# PRODUCT BULLETIN # 20543

Issue Date: 11-Jul-2014

**TITLE:** Change in Shipping Bag

**Typical Bag Configuration**

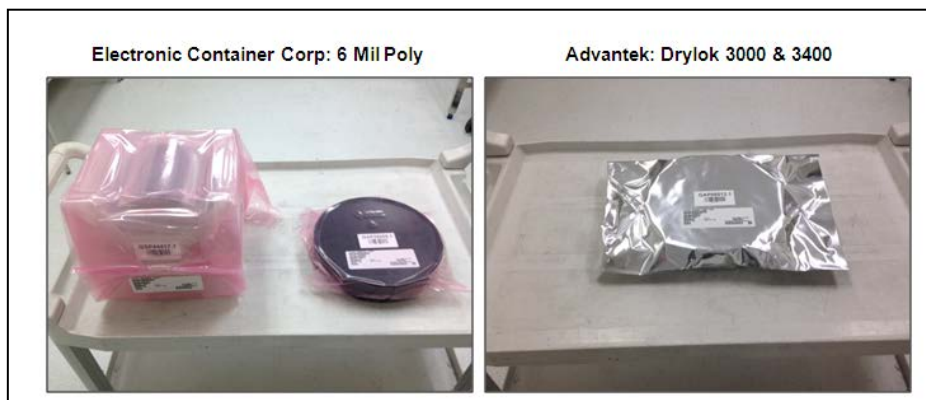
Change from poly shipping bag to foil shipping bag for production wafers. New bag suggested for Gresham is the same bag as is used in Pocatello. The new bag is a standard shipping bag for ON Semi and meets all of ON Semi's internal specs.
